## **CAMELLIA MANOR SUBDIVISION**

Engineering Comments: FINAL PLAT COMMENTS (should be addressed prior to submitting the FINAL PLAT for review and/or signature by the City Engineer):

APPLICATION NUMBER 4 DATE January 5, 2017

# DETAIL SITE PLAN

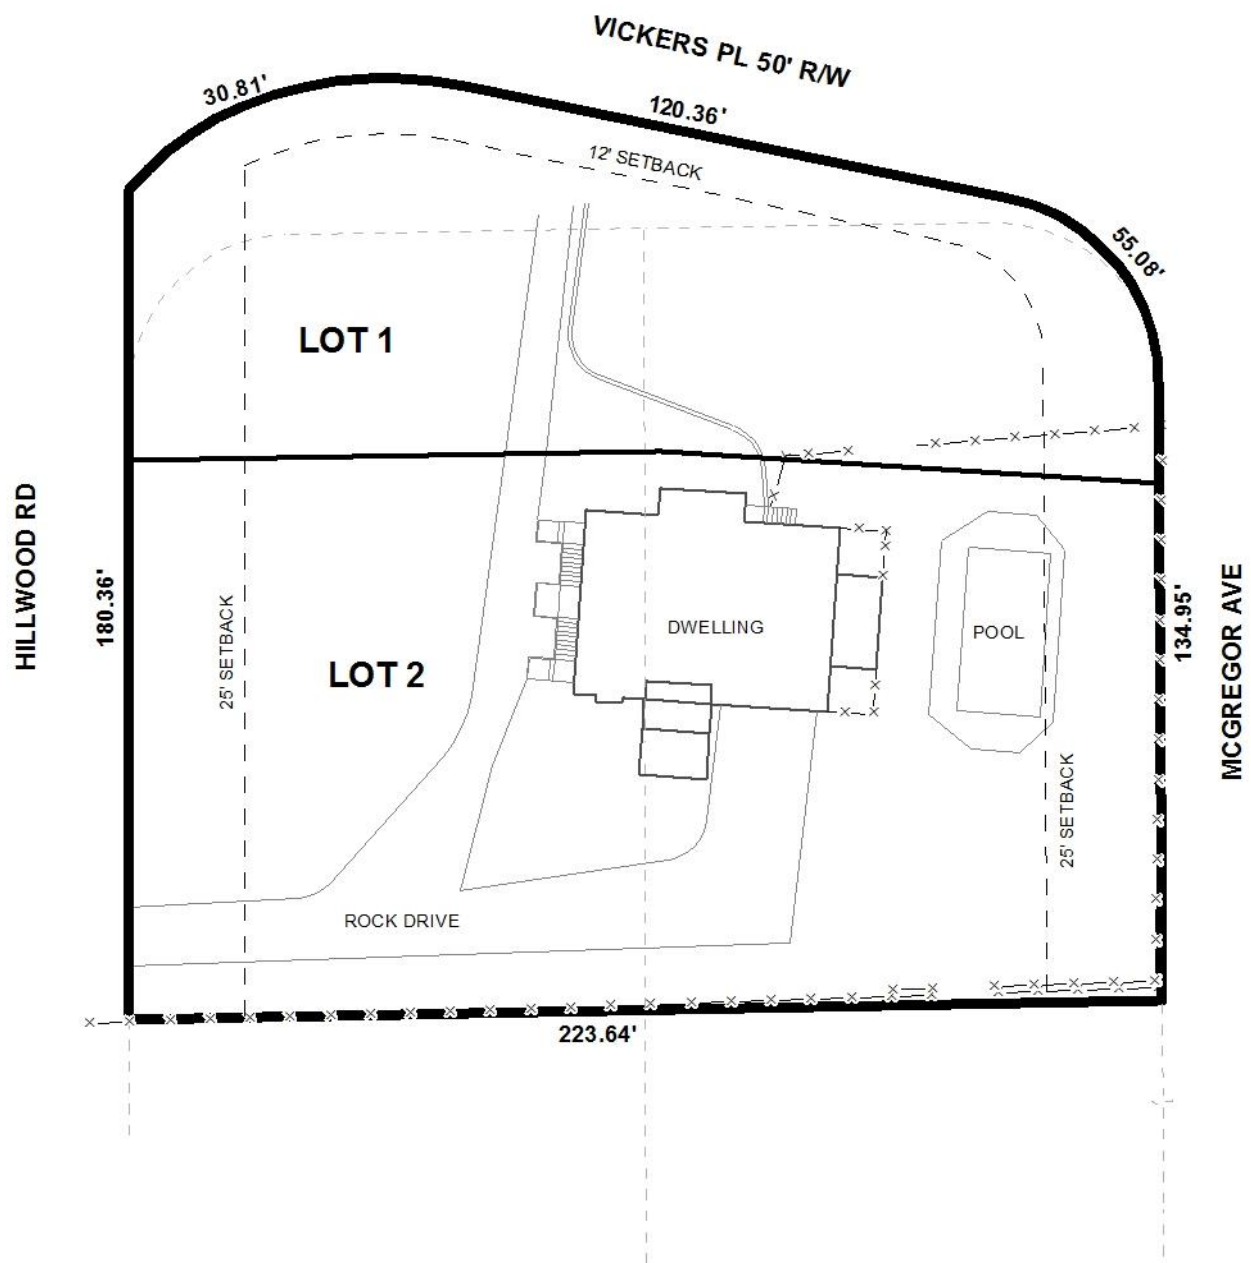
The subject lots have frontage on three streets, which consist of Hillwood Avenue, Vickers Place, and South McGregor Avenue. Hillwood Avenue is a minor street with ribbon curb and gutter, and as such requires a 50 foot wide right-of-way width. The preliminary plat illustrates a distance of 35 feet from the right-of-way to the centerline along Hillwood Road, and, if approved should be retained on the Final Plat. Vickers Place, also a minor street, has no curb and gutter, and the right-of-way width is depicted as 50 feet on the preliminary plat. The 50 foot right-of-way was allowed as part of a 2013 vacation of right-of-way, thus no dedication should be required. McGregor Avenue is a planned major street as shown on the Major Street Plan Component of the Comprehensive Plan, and due to the atypical nature of South McGregor Avenue, a minimum right-of-way width of 80 feet is required. The plat depicts 30 feet from the centerline, which, in combination with the previously allocated right-of-way across McGregor, is sufficient. The plat should be revised to reflect total right-of-way.

The 25-foot minimum building setback line is depicted on the preliminary plat along Hillwood Road and South McGregor Avenue, and as such, should be retained on the Final Plat, if approved. Additionally, it should be noted that the applicant has requested a waiver of Section V.D.9. of the Subdivision Regulations to allow a 12' setback along Vickers Place. Section V.D.9. of the Subdivision Regulations requires a 25' building setback; however, Section 64-4.D.3. of the Zoning Ordinance allows for reduced setbacks for a side street on a corner lot. If approved, the 12' minimum setback line along Vickers Place should be retained on the Final Plat.

The proposed lots, ranging from 15,000 – 26,000 square feet, exceed the 7,200 square foot minimum lot size requirement for lots served by public water and sanitary sewer systems; however, the lot size information is only indicated in square feet. The lot size information should be depicted in both square feet and in acres on the Final Plat, if approved.

As a means of access management, a note should be placed on the Final Plat stating that Lot 1 is limited to one curb cut to Vickers Place, exact location to be coordinated with Traffic Engineering, and that Lot 2 is limited to the existing curb cut to Hillwood Road, with any changes in the size, location and design to be approved by Traffic Engineering and conform to AASHTO standards. Additionally, a note should be placed on the Final Plat stating that Lots 1 and Lot 2 are denied access to McGregor Avenue.

- 1) Retention of the right-of-way width along Hillwood Road;
- 2) Revision of the plat to label the entire right-of-way of South McGregor Avenue;
- 3) Retention of the 12-foot minimum setback line along Vickers Place;

- 4) Revision of the lot size information to include both the square feet and acres of each lot;
- 5) Placement of a note on the Final Plat stating that Lot 1 is limited to one curb cut to Vickers Place, exact location to be coordinated with Traffic Engineering, and that Lot 2 is limited to the existing curb cut to Hillwood Road, with any changes in the size, location and design to be approved by Traffic Engineering and conform to AASHTO standards;

- 6) Placement of a note on the Final Plat stating that Lots 1 and Lot 2 are denied access to McGregor Avenue.;
- 7) Compliance with Engineering comments: *(FINAL PLAT COMMENTS (should be addressed prior to submitting the FINAL PLAT for review and/or signature by the City Engineer): A. Provide all of the required information on the SUBDIVISION PLAT (i.e. signature blocks, signatures, certification statements, written legal description, required notes, legend, scale, bearings and distances) that is required by the current Alabama State Board of Licensure for Professional Engineers and Land Surveyors. B. Add Vickers Place to the vicinity map. C. Review and revise the written legal description to include a written arc distance along Vickers Place. D. Show and label each and every Right-Of-Way and easement. E. Provide and label the monument set or found at each subdivision corner. F. Add a signature block for the Owner, Notary Public, Planning Commission, Traffic Engineer, and City Engineer. G. Provide the Surveyor's, Owner's (notarized), Planning Commission, and Traffic Engineering signatures. H. Add a note to the SUBDIVISION PLAT stating that a Land Disturbance permit will be required for any land disturbing activity in accordance with Mobile City Code, Chapter 17, Storm Water Management and Flood Control); the City of Mobile, Alabama Flood Plain Management Plan (1984); and, the Rules For Erosion and Sedimentation Control and Storm Water Runoff Control. I. This area has been designated by the City Engineer as an area prone to localized flooding. Any development must meet the requirement of providing detention for the postdeveloped 100 yr storm event with an allowable release rate equal or less than the predeveloped 2 yr storm event. J. Add a note to the Plat stating that the approval of all applicable federal, state, and local agencies (including all storm water runoff, wetland and floodplain requirements) will be required prior to the issuance of a Land Disturbance permit. K. Add a note that sidewalk is required to be constructed, and/or repaired, along the frontage of each lot, or parcel, at time of new development or construction, unless a sidewalk waiver is approved. L. Provide a copy of the FINAL SUBDIVISION PLAT to the Engineering Dept. for review. No signatures are required on this drawing. M. After addressing all of the FINAL SUBDIVISION PLAT review comments by the Engineering Dept. provide the ORIGINAL and one (1) copy of the*
